FIELD SERVICE CAMPAIGN – 21123

21 December 2021

Rear Heating Ventilation and Air Conditioning (HVAC)

International® HX® Series Trucks

Figure 2. Sleeper PDM

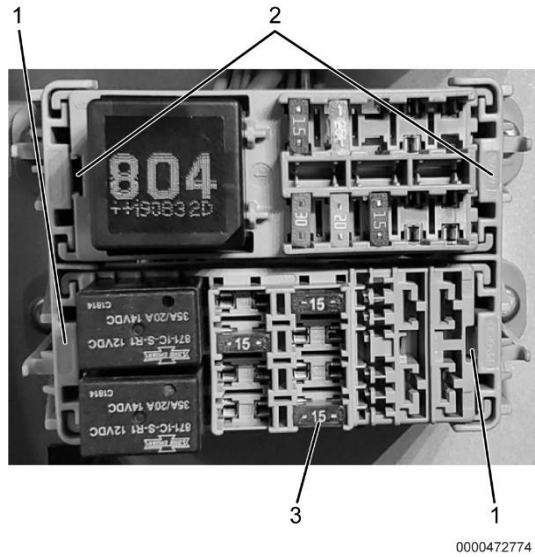
8. Remove 15 AMP HVAC fuse (Figure 2, Item 3).
9. Using a small flat screwdriver, disengage PDM support locking tabs (Figure 2, Items 1 & 2) and remove upper and lower sleeper PDM from support.
10. Remove upper sleeper PDM terminal lock. Save for reuse.
11. Remove lower sleeper PDM terminal lock. Save for reuse.

Figure 3. 4002 Lower Sleeper PDM

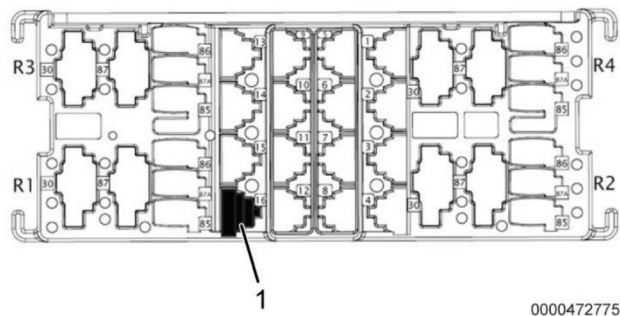
12. Using terminal release tool, remove terminal wire H01-174-BLA from cavity 16 (Figure 3, Item 1).

Figure 4. Terminal Tab

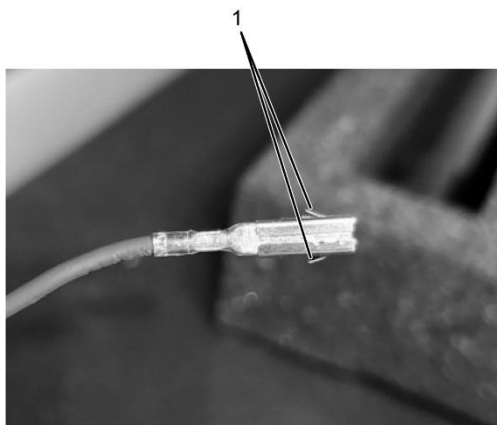
13. Ensure two terminal tabs (Figure 4, Item 1) are slightly extended.

Figure 5. 4001 Upper Sleeper PDM

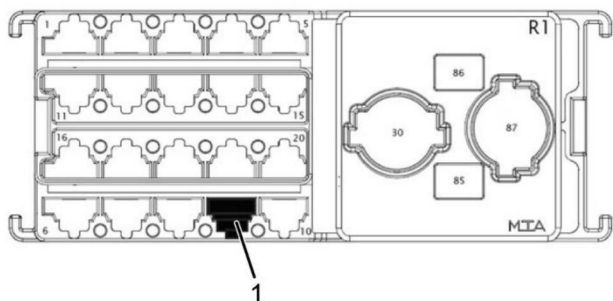
14. Populate terminal wire H01-174-BLA into R/D 4001 cavity 11 position A (Figure 5, Item 1).
15. Install upper sleeper PDM terminal lock.
16. Insert lower sleeper PDM terminal lock.
17. Install upper PDM grid and lower PDM grid into bracket support.

Figure 6. Sleeper PDM

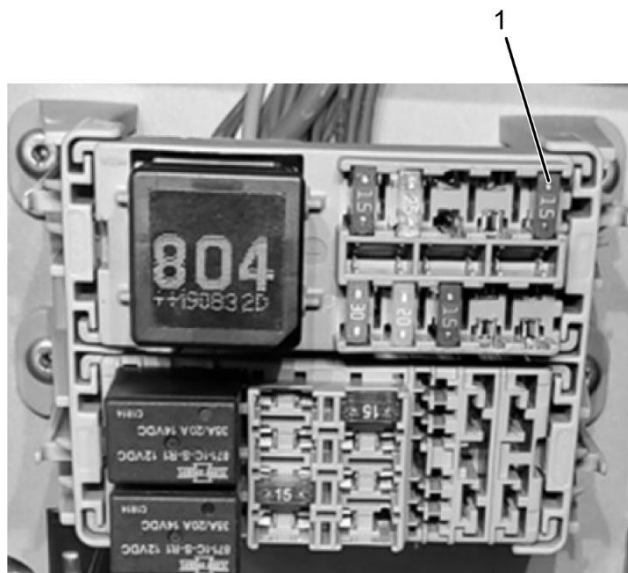
1. New fuse location
18. Install previously removed 15 AMP HVAC fuse into new fuse location (Figure 6, Item 1).

Figure 7. Sleeper PDM Cover

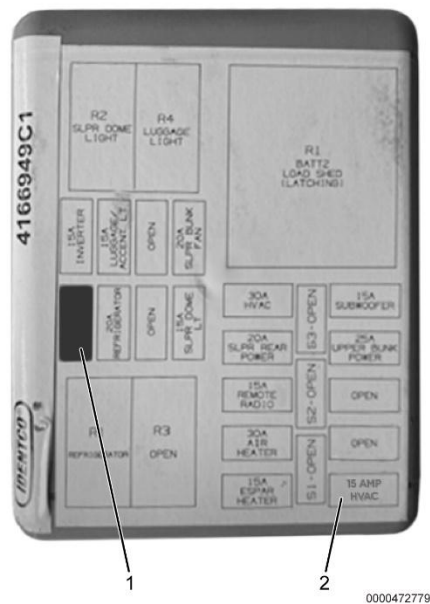
19. Using a black marker, cover 15 AMP HVAC letters of fuse old location (Figure 7, Item 1).
20. Using a black marker, rename new fuse location to 15 AMP HVAC (Figure 7, Item 2).
21. Install sleeper PDM cover.
22. Close driver-side luggage door.
23. Clean battery terminal with wire brush. Then clean with electrical contact cleaner and dry with shop air.
24. Apply BLUE dielectric grease to battery terminal stud, negative battery cable ring terminal, and threads of new battery stud nut.
25. Using new battery stud nut, reconnect negative battery cable to negative terminal on main vehicle battery and install new battery terminal nut.
